## Intel Bay Trail-M Platform Block Diagram

**Quanta Computer Inc.**  
PROJECT : NL6

Size Document Number Rev 1A  
Intel Block Diagram  
Date: Friday, April 25, 2014 Sheet 1 of 41

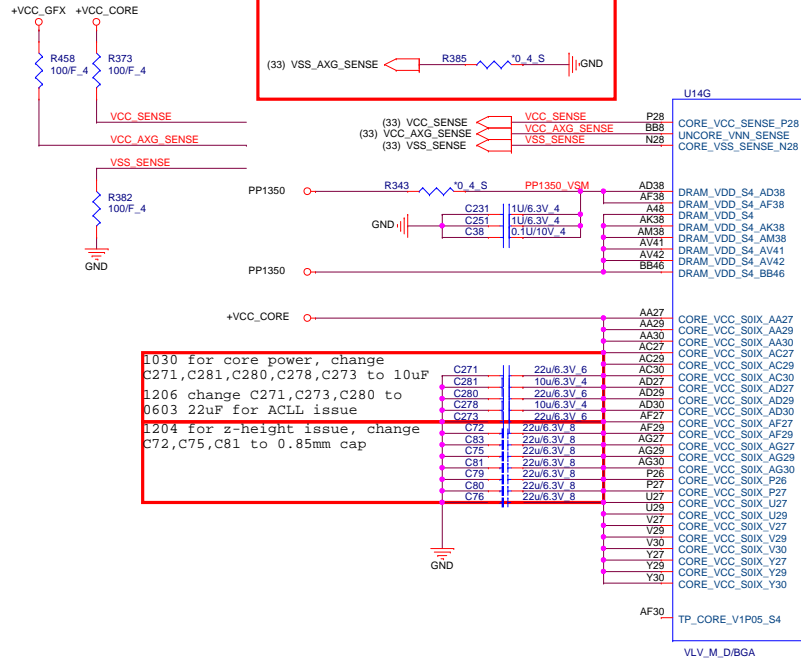
1031 for layout suggestion by intel, VSS\_AXG\_SENSE didn't connect to VSS\_SENSE, will connect the GND via near VCC\_AXG\_SENSE  
1031 for layout, add 0hm between GND and VSS\_AXG\_SENSE

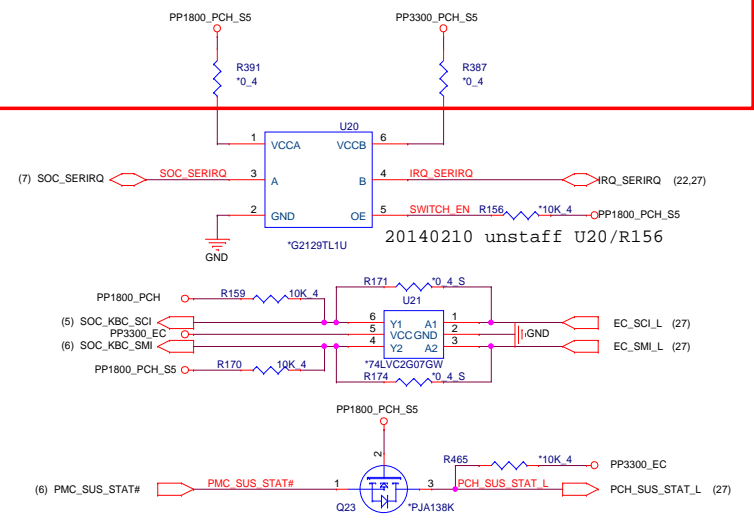
9/6 EC table says SERIRQ is OD pin, reserve for debugging  
 1128 remove R166, because SERIQR of TPM needs 3V  
 1128 reserve 0 ohm R387/R391 on VCCA and VCCB for debugging  
 20140210 unstuff R387/R391

# PWRON SEQUENCE

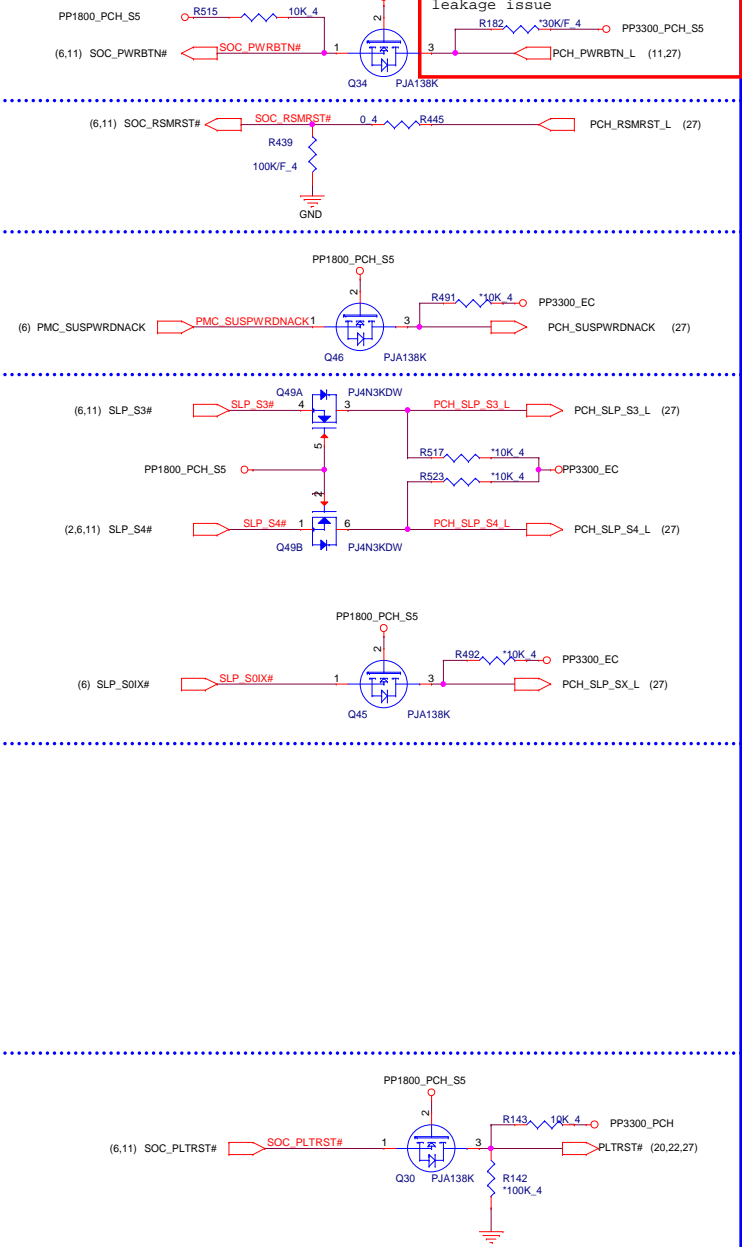
0128 change power rail of Q35,Q36,Q37,Q44 from PP1800\_PCH\_S5 to PP1800\_PCH for PP1800\_PCH leakage issue in S3 mode

0206 remove/delete SPI\_SIO Interface, Q35,Q36,Q37,Q44,R486,R484,R485,R483,R426,R429,R427,R428

## SD/MMC CARD READER CONNECTOR (MMC)

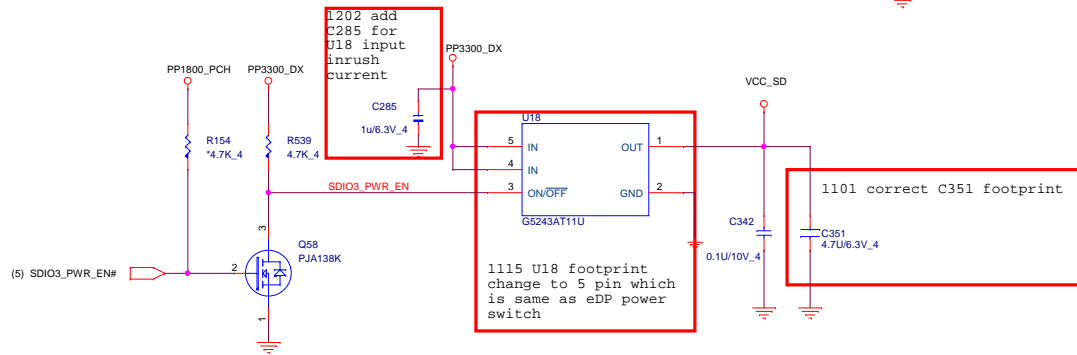
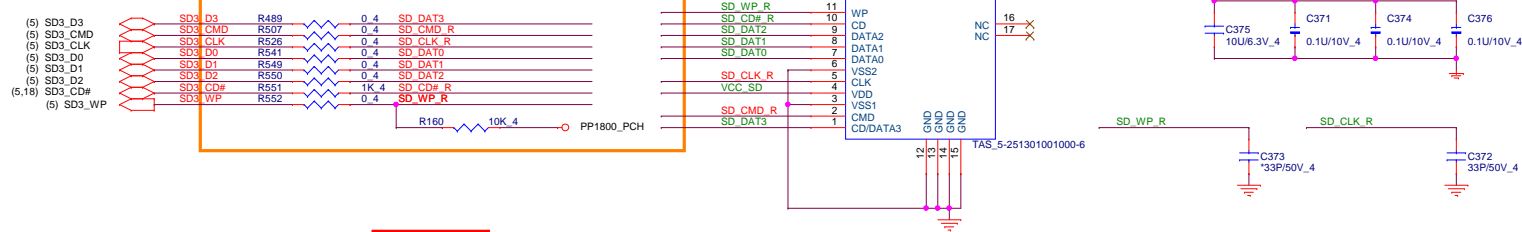
1205 the damping of SDIO change to 0 ohm by Intel request  
 1205 add PU for SDIO WP by Intel request  
 1205 R551 changes to 1K to isolate SD socket and servo/SoC  
 1205 SD3\_WP is 1.8V power rail in SoC, change external Pulled up power well of SD3\_WP to 1.8V power

1211 add pulled up resistors on SDIO data/cmd lines  
 1212 all pulled up resistors of SDIO data/cmd to be un-stuffed

## HEADPHONE/Mic combo(ADO)

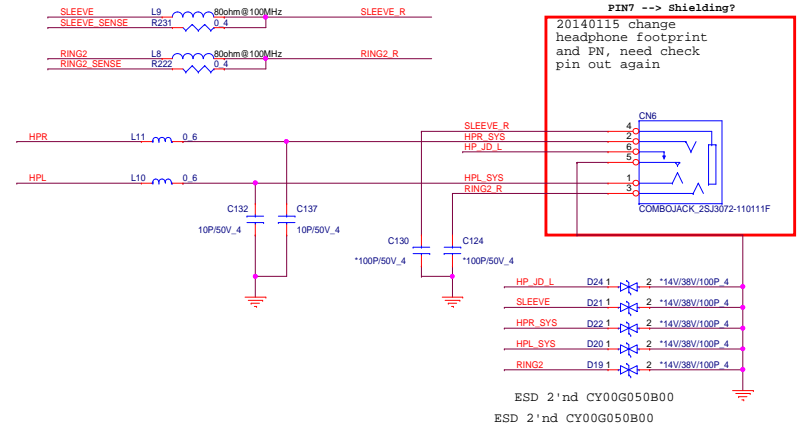
20140115 change  
headphone footprint  
and PH, need check  
pin out again

### Track PAD BOARD CONN (TPD)

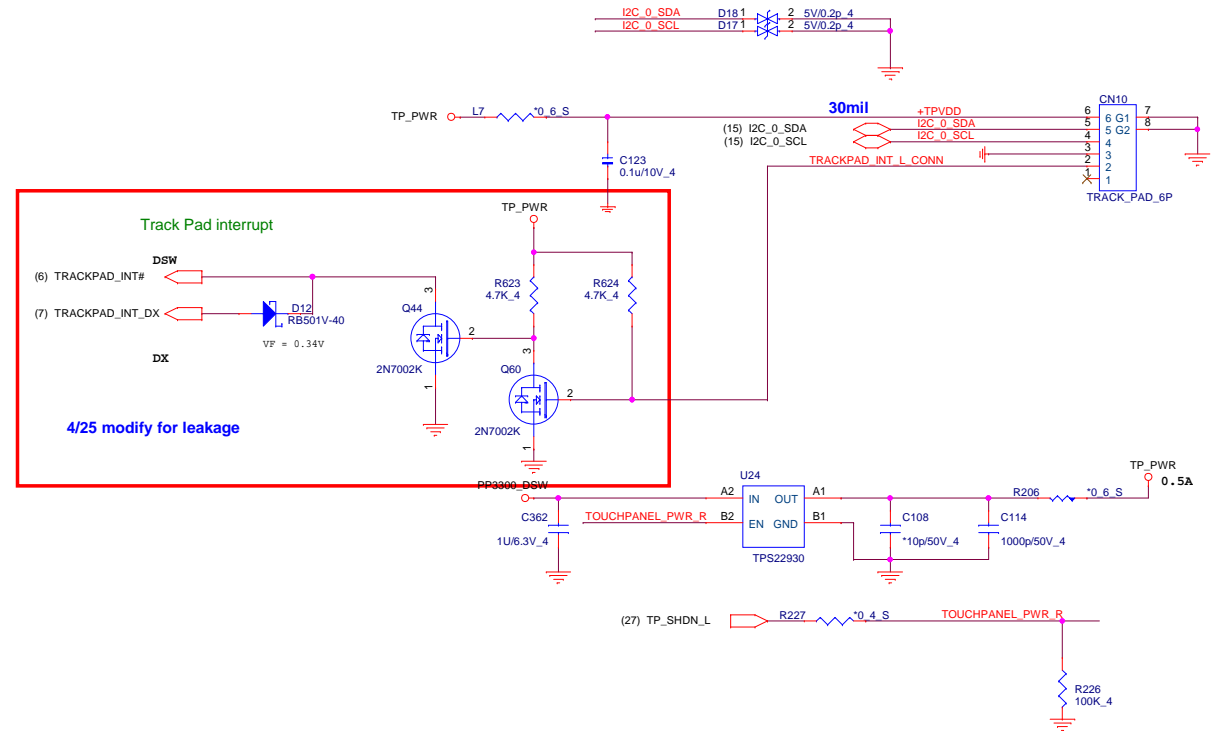
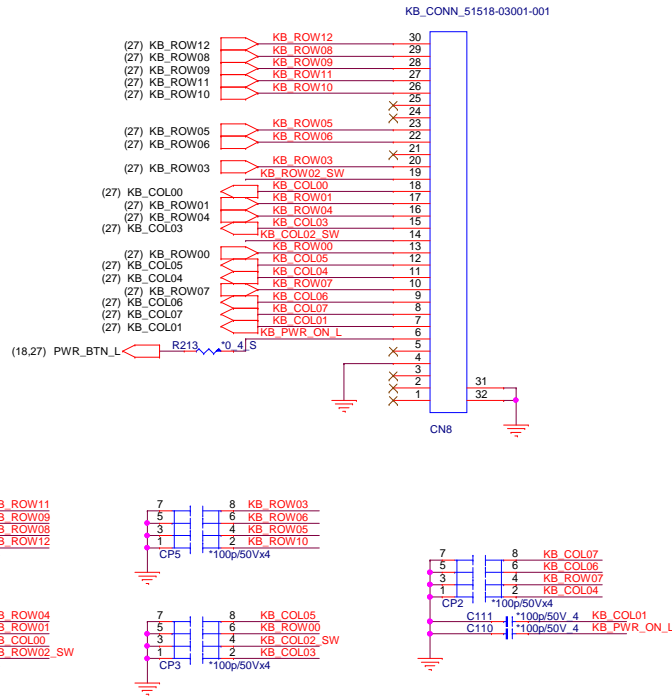
20140127 Change KB CONN for ME require

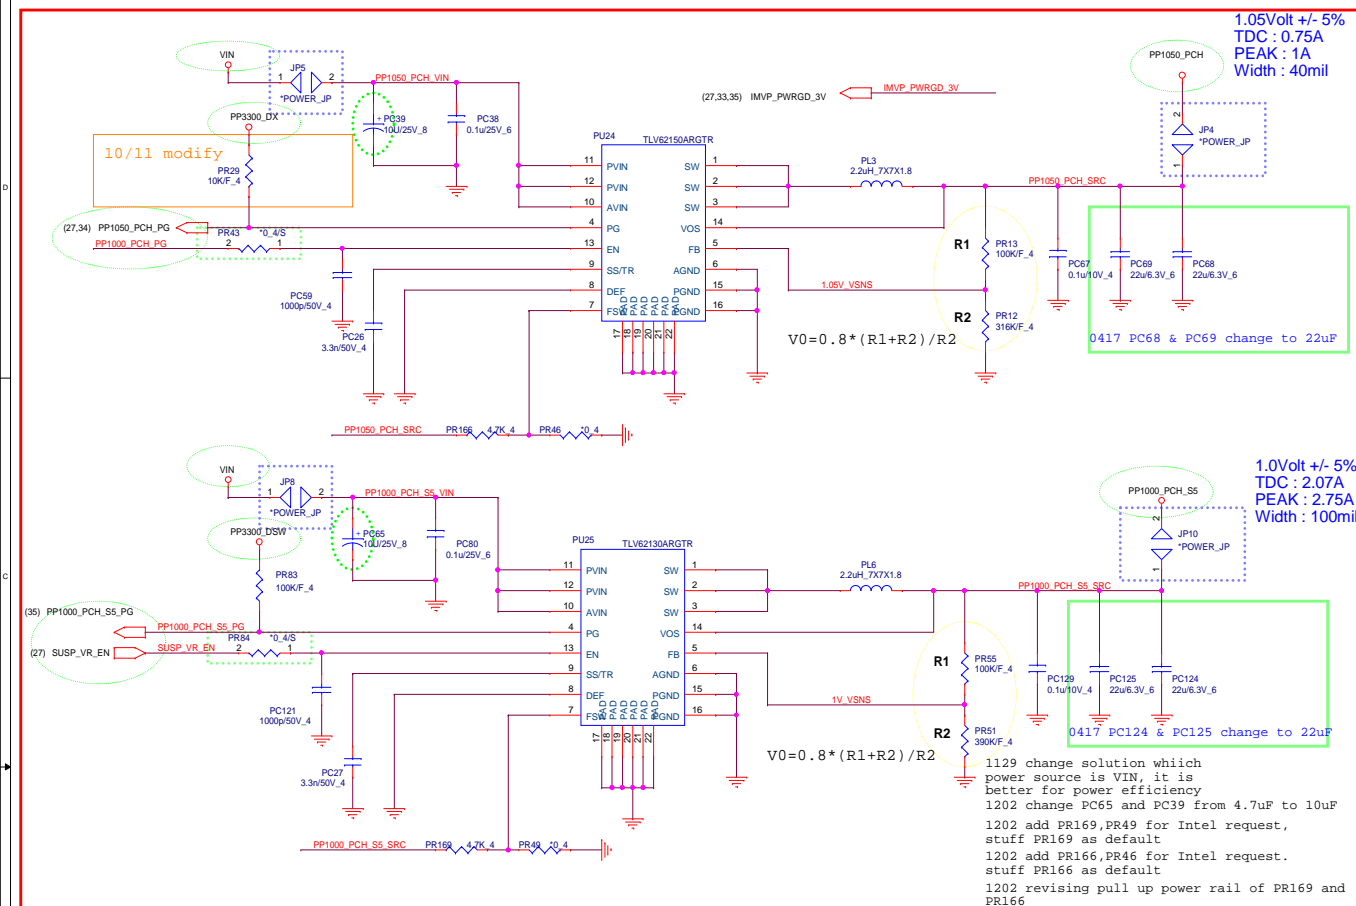
Close to output cap  
0417 PR21 change to 3.3ohm ,  
PC32 change to 1200uF , PC29  
change to 10uF

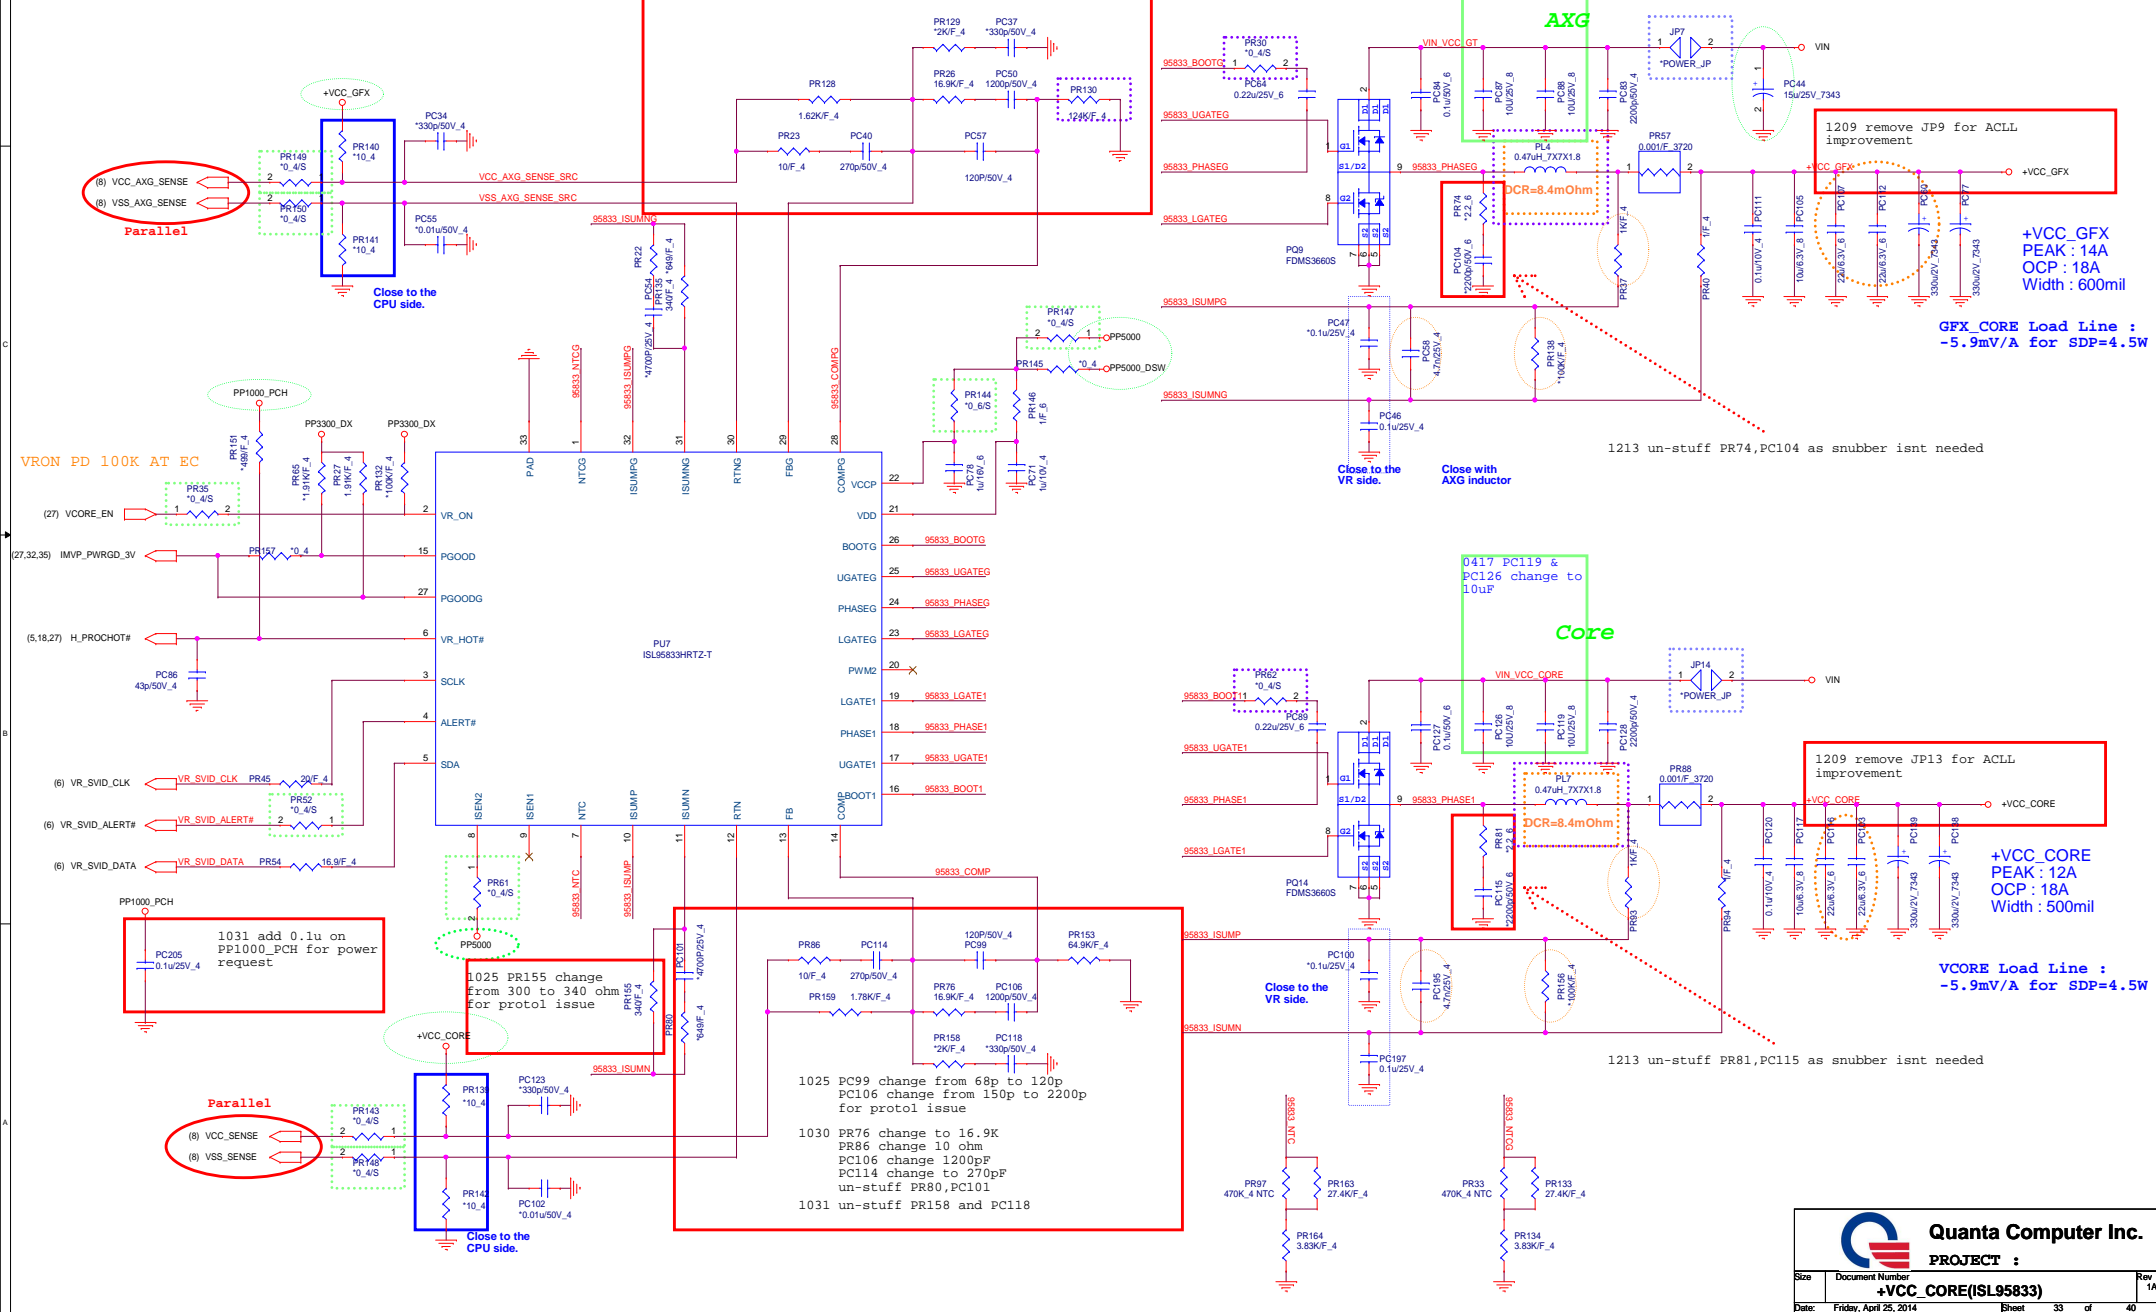
1025 PC99 change from 68p to 120p  
PC106 change from 150p to 2200p  
for protol issue

1030 PR76 change to 16.9K  
PR86 change 10 ohm  
PC106 change 1200pF  
PC114 change to 270pF  
un-stuff PR80, PC101

1031 un-stuff PR158 and PC118

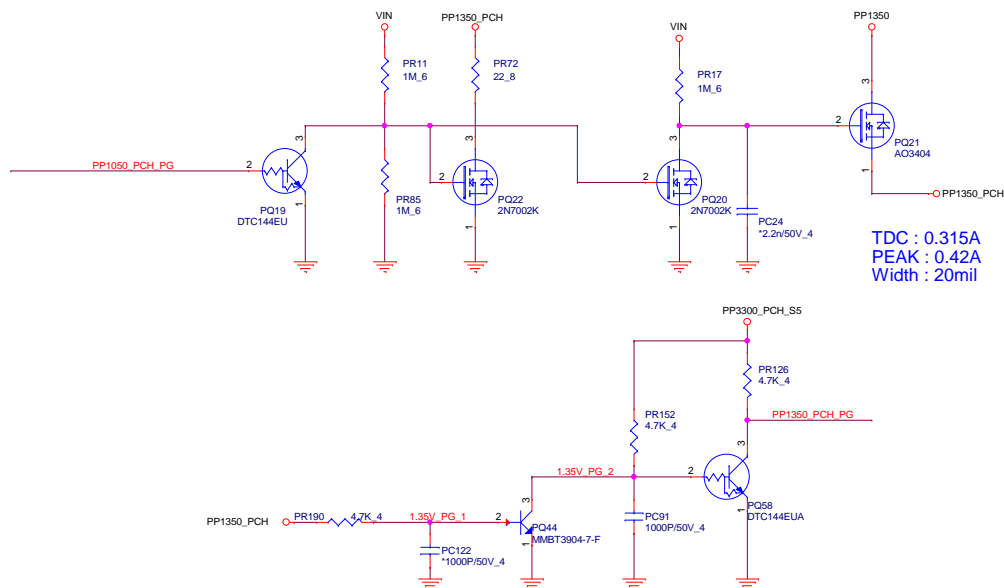
1129 PP1000\_PCH\_S5 change from LDO to switching power

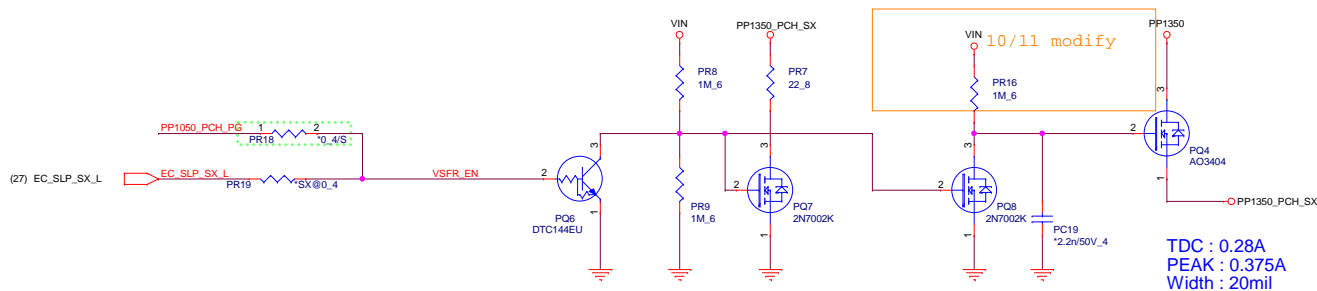
1129 PP1350\_PCH change from LDO to power MOSFET
